Groundwater Management Plan

Santa Clara River Valley Groundwater Basin, East Subbasin

CASTAIC LAKE WATER AGENCY

December, 2003

Figure 3-2
Historical Groundwater Elevations
Santa Clara River Valley East Groundwater Subbasin

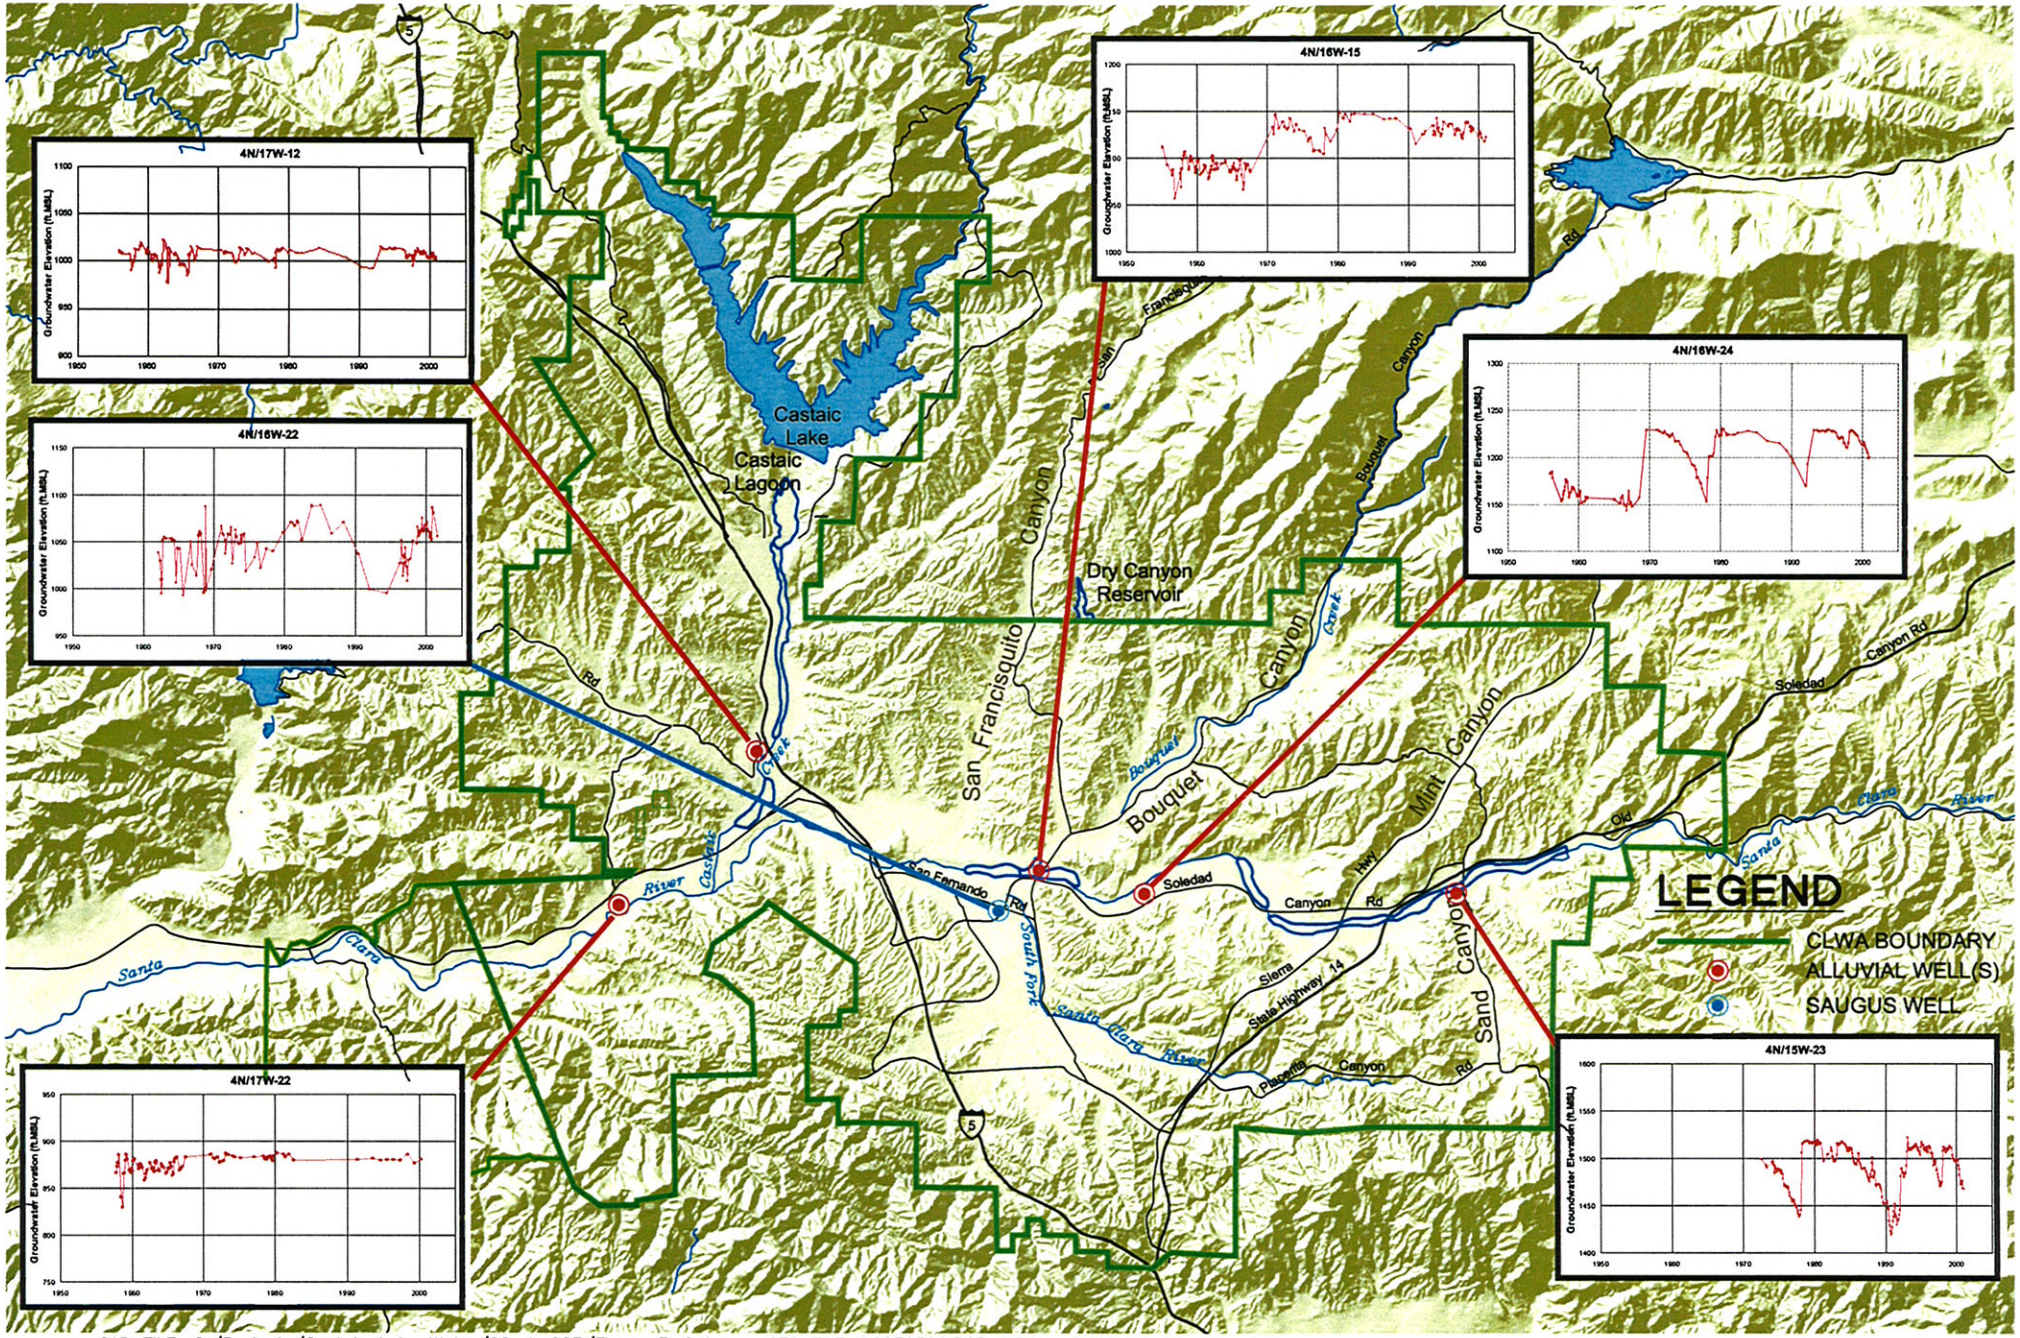
Figure 3-2. The vertical and horizontal scales associated with the hydrographs are very difficult to read. The T4N/R17W, Section 22 well, in the western arm of the Alluvial Aquifer does not show data from approximately 1983 through 1991. In previous reports and analyses, the NLF #C5 well was used for this area. This well depicted variable groundwater levels for the period from the mid-1980s to the early 1990s. Because this is the discharge area of the Alluvial Aquifer to the Santa Clara River, we need to understand the response of the system to the onset of agricultural pumping in this area in the mid-1980s. The T4N/R17W, Section 22 well does not possess the data needed to show that response;

Figure 3-3
Historical Groundwater Quality by Section
Santa Clara River Valley East Groundwater Subbasin

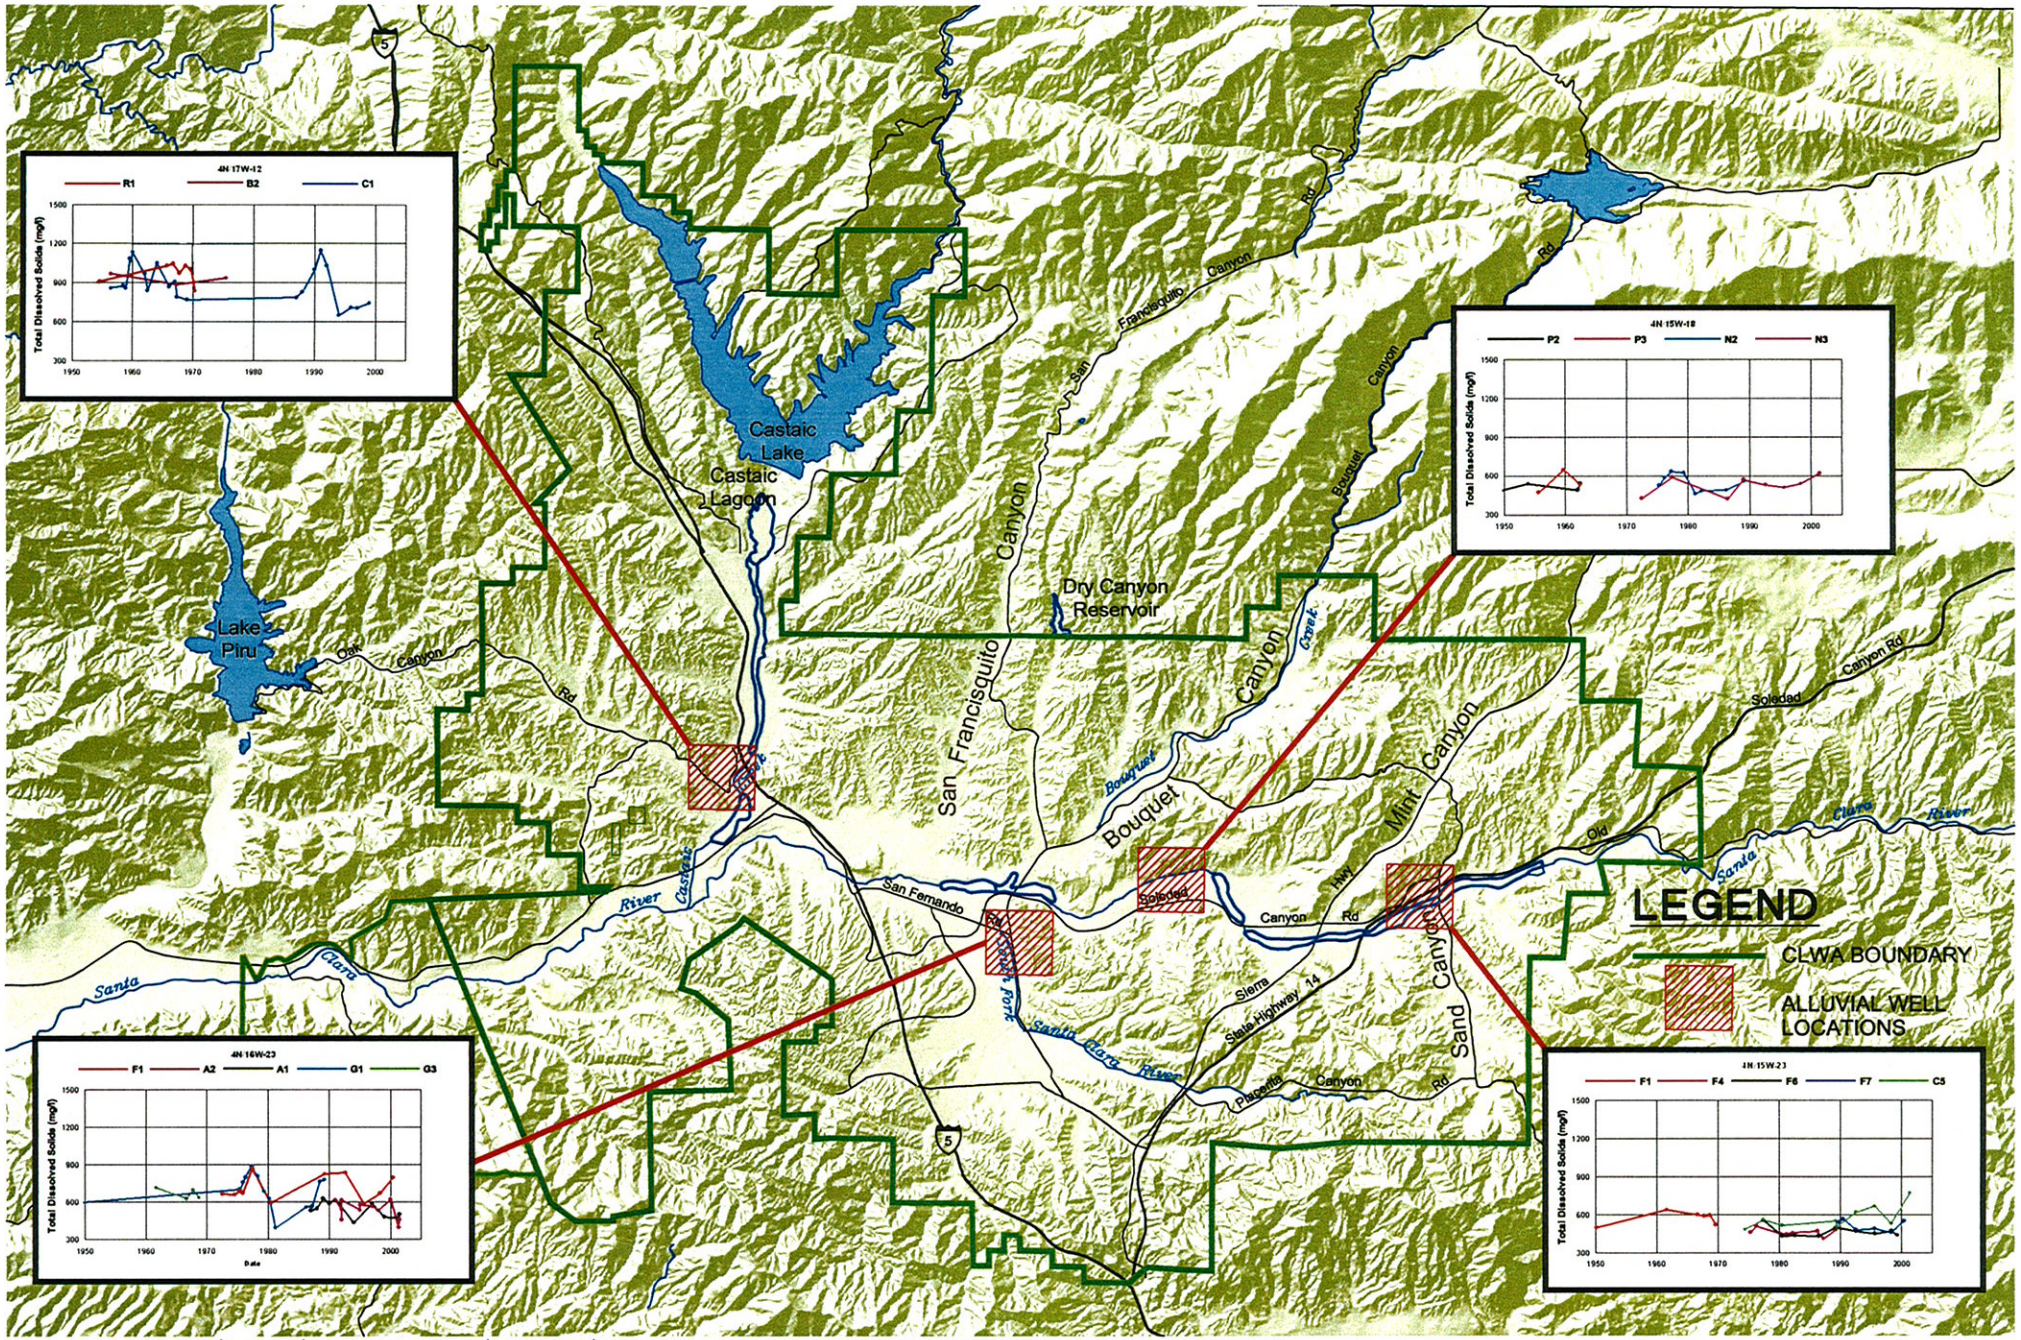
Page 15. The comment near the top of the page that "*over the last 35 years, groundwater quality in the Saugus has remained generally constant*" would be more supportable if it was accompanied by a groundwater quality map similar to Figure 3-3, with a few groundwater quality time-series specific to the Saugus Formation;

Figure 5-1
Water Level Monitoring Well Network
Santa Clara River Valley East Groundwater Subbasin

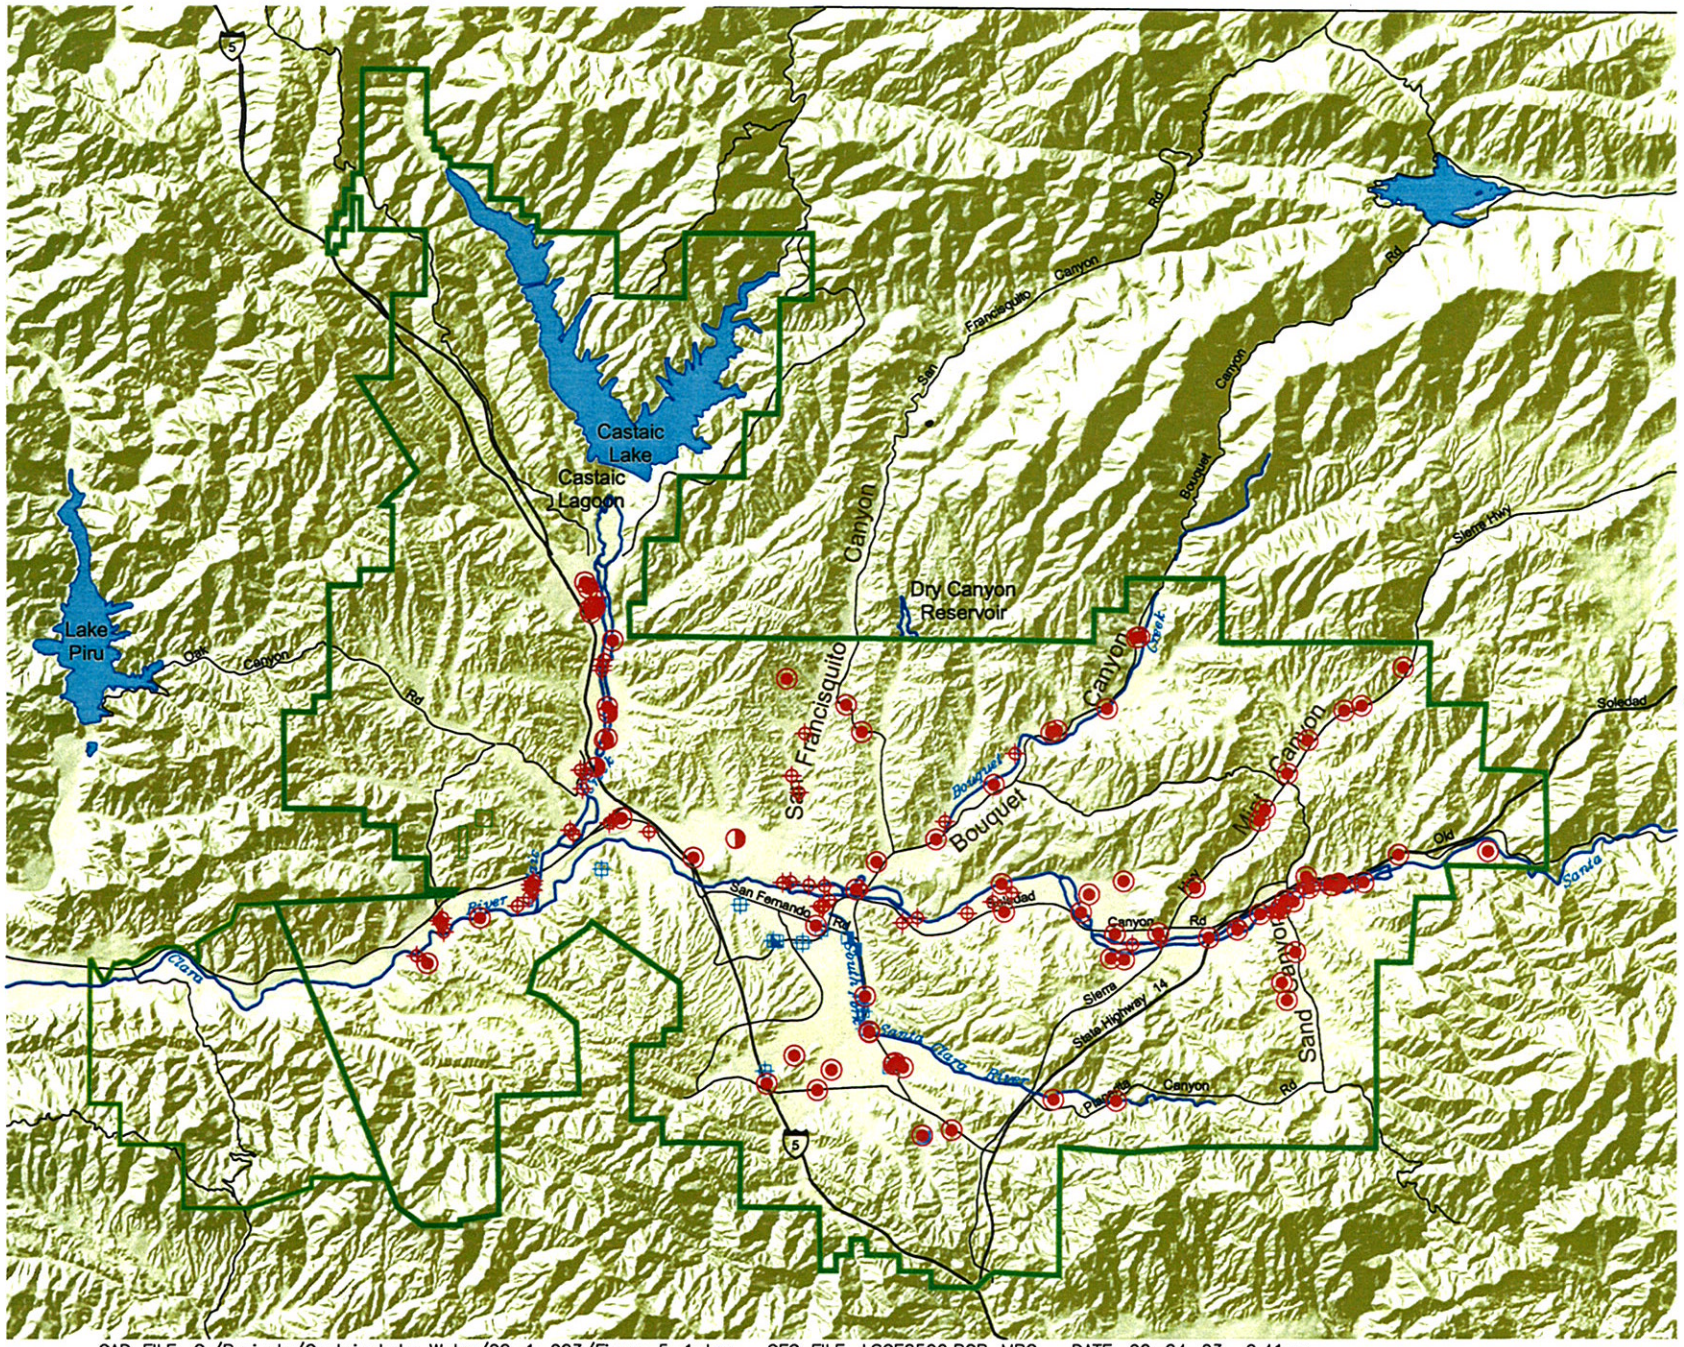
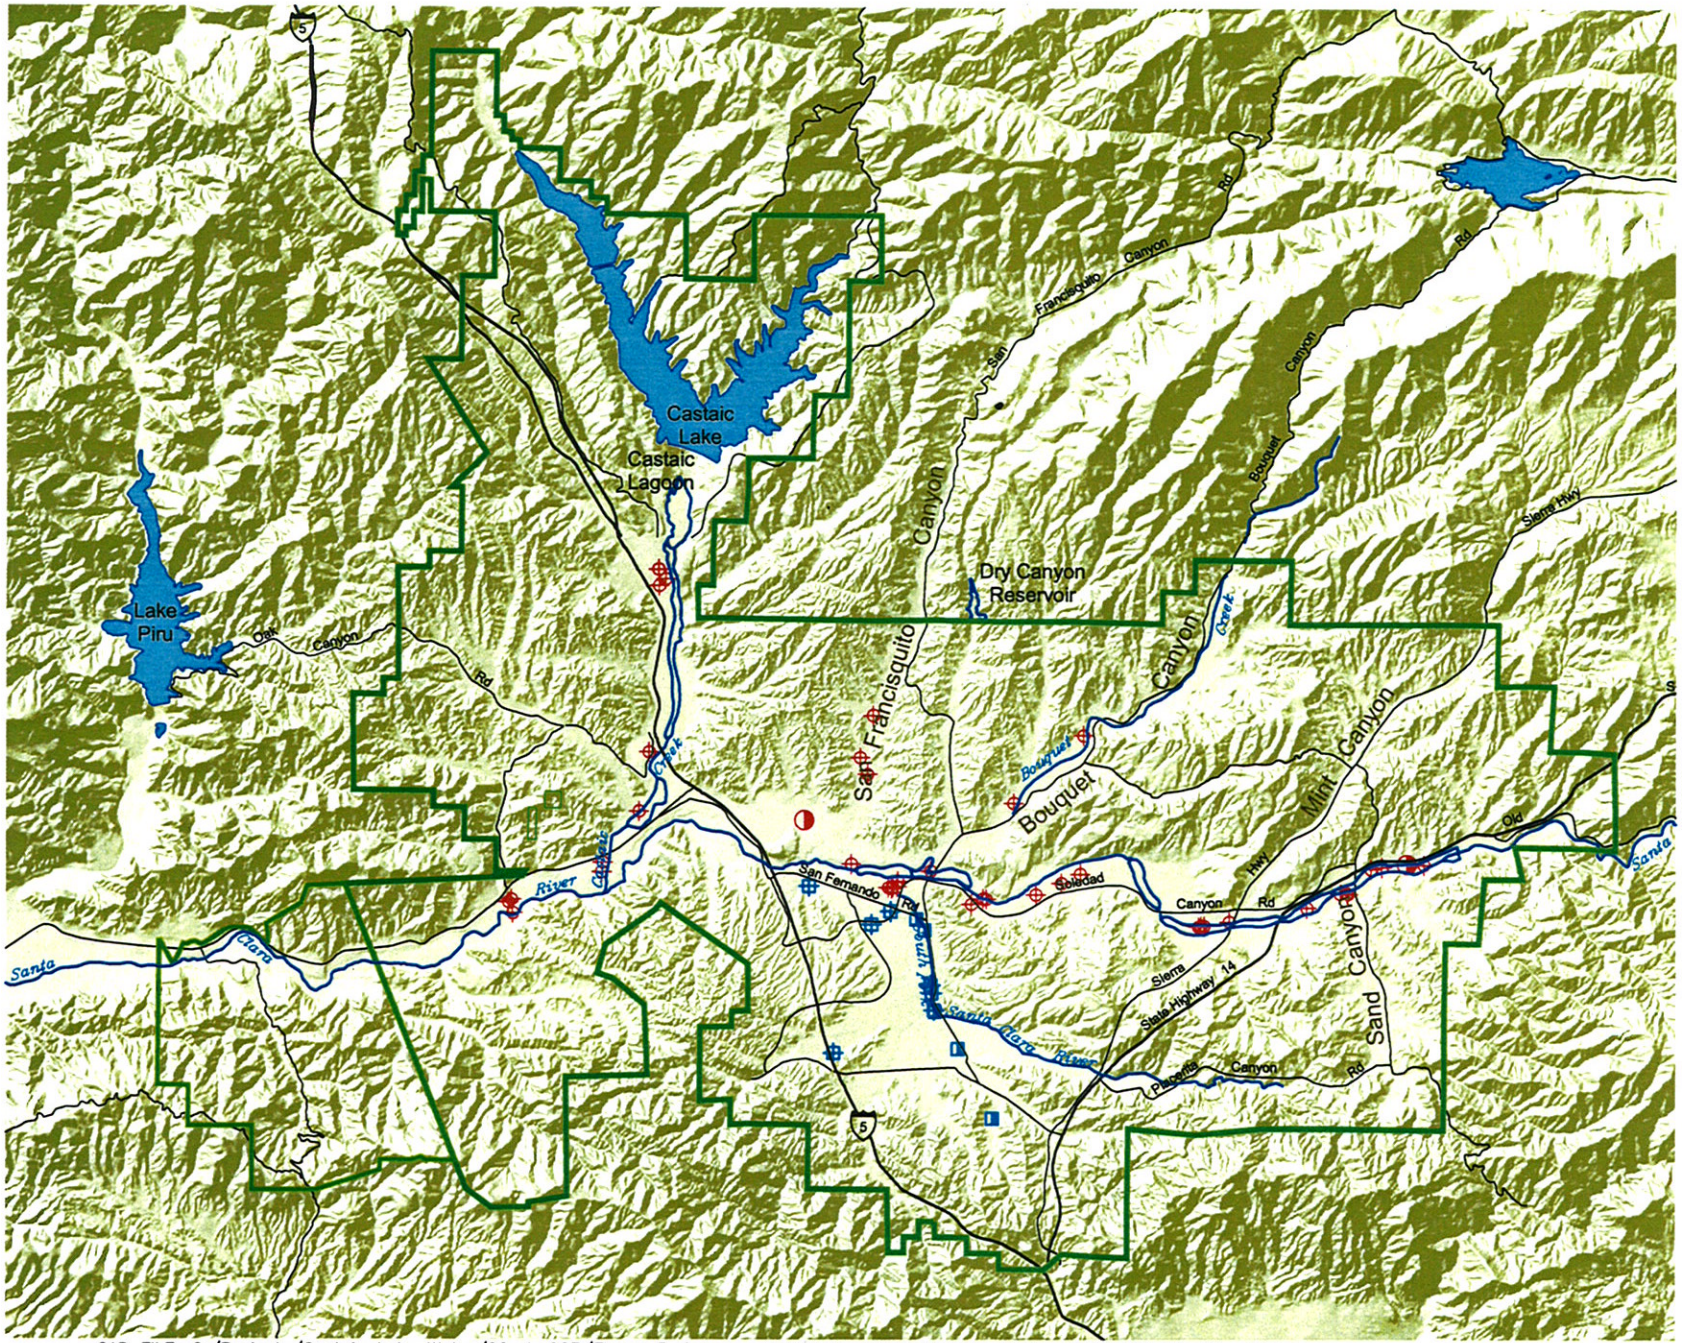
First, I commented previously on the proposed network of monitoring wells and the public availability of data. The monitoring wells in figures 5-1 and 5-2 appear to cover a wide range of the valley. However, the text on p. 27 states the network will be "mostly as illustrated in figures 5-1 and 5-2, but possibly expanded...." I hope the final network is extensive and covers all areas of the valley. Further expansion of the network would add valuable data points and should be encouraged.
